Metropolitan Planning Commission

Staff Reports

February 11, 2010

Zone Change 2009SP-022-002 Mansion at Fontanel SP, Phase II

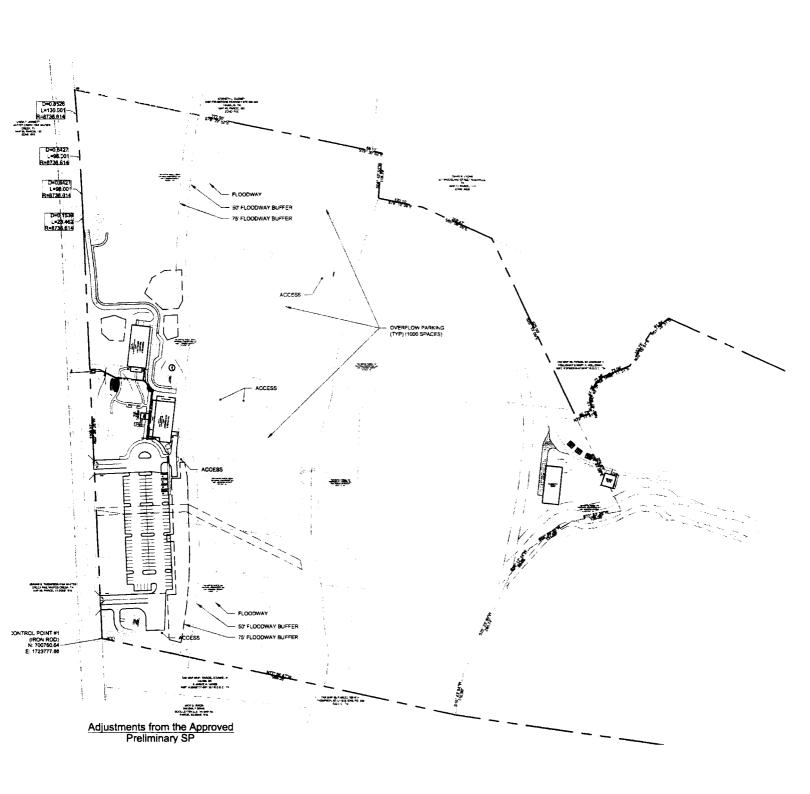
- Provide a completed Dedication of Easements. For the detailed Long Term Maintenance Plan, include inspection / maintenance procedures for the temporary parking in the buffers. Also, provide an exhibit sheet. Provide recording fees.

- 2. Provide the Grading Permit fee (\$1060) and provide NOC.
- 3. For initial erosion control measures, provide a sediment trap and diversions.
- 4. Provide adequate stabilization methods for all slopes 3:1 or steeper.

- 5. For the storm pipes, PVC is not allowed.
- 6. Provide a larger (and to scale) pre / post drainage maps.
- 7. For the detention calculation, change the time interval to 1 minute.

- 8. For the detention pond freeboard, provide top of bank elevations.
- 9. For Basin 1 water quality measure H-Ho, the H should be to the elevation of the first orifice above the live pool orifice (should be 451.1 not 451.5). You used the old Pond Report information. For water quality ponds at Basins 2, 4, and 5, where did the H-Ho come from? For the orifice at Basin 5, round down. Also, provide stage storage information. For water quality Basin 7, it appears that some area may not drain towards the infiltration trench. Revise grading or add notes to the plan (about flow paths).

- 10. For the cut / fill compensation, revise and do not include area listed within the pond limits (show the pond elevation on sections.
- 11. If a gravel access road is proposed within the buffer area, provide a buffer restoration plan for review.

12	2. Add note stating that buffer signs shall be installed at the buffer area. Specify locations of signs on plans and add detail of sign to plans.
FIRE MARSHAL RECOMMENDATION	Α	ll applicable Fire Codes shall be adhered to.
NES RECOMMENDATION	1)	As exists today there is only single phase power available from Whites Creek (back to the old house),

2)	see attached drawing. Developer to provide a civil duct and gear (pad/switcl locations for NES review and approval. This shall cover the entire project area.

3)	Developer drawing should show any existing utilities easements on property and the utility poles and the existing NES ugrd facilities on the property and/or r-o

4)	w. 20-foot public utility easement required adjacent to public r-o-w.
	5)	20 foot easement is required to be centered over the existing underground conduits and equipment.

6)	20 foot easement is required to be centered on the new conduit and equipment.
	7)	NES can meet with developer/engineer upon request of determine electrical service options. Schedule meeting with ESE and Customer engineering will attend.

8)	NES needs any drawings that will cover any road improvements to Whites Creek Pike that Metro Public Works will require.
	9)	NES follows the National Fire Protection Association rules; Refer to NFPA 70 article 450-27; and NESC Section 15 - 152.A.2 for complete rules (see NES Construction Guidelines under "Builders and Contractors" tab @ www.nespower.com).
PUBLIC WORKS RECOMMENDATION

2.	
	3.	Install "Private Access Only" sign at the main mansion drive.

- 4. Provide "Do Not Enter" signage and/or gates for shuttle service drive where it ties into the main mansion drive.
- 5. Install appropriate signage at entry points to overflow parking areas.

- 6. Install physical barrier at office gravel lot to prevent access to special event grass parking area.
- 7. Add note to plans limiting main mansion driveway use to staff and shuttles.

- 11. Provide plans for three evenly spaced pullouts along main access driveway between the bridge and mansion. Provide appropriate signage.

- 1. The location, size, and design of any structures proposed for Phase III shall be reviewed and approved by staff prior to final site plan approval for that phase.
- 2. A separate water and sewer capacity study shall be submitted for the micro-brewery when it is added to

the property. Any additional fees required to support this use shall be paid prior to the issuance of a use and occupancy permit for the micro-brewery. If the micro-brewery is to be in a structure not approved with this plan, the location, size and design of the structure shall be reviewed and approved by staff and any additional water and sewer capacity fees shall be paid prior to the issuance of building permits.

- 3. Details of the lighting for the entrance signs shall be reviewed and approved by staff and included on the corrected copy of the SP final site plan.

- 4. Buses shall not be permitted to idle when parked in the designated tour bus parking area on the south side of the property. A note shall be added to the corrected copy of the SP final site plan that no idling of buses will be permitted in this location as well as a description of how this shall be enforced. A designated location for bus drivers to wait while tours are in progress shall be shown on the corrected copy of the SP final site plan.
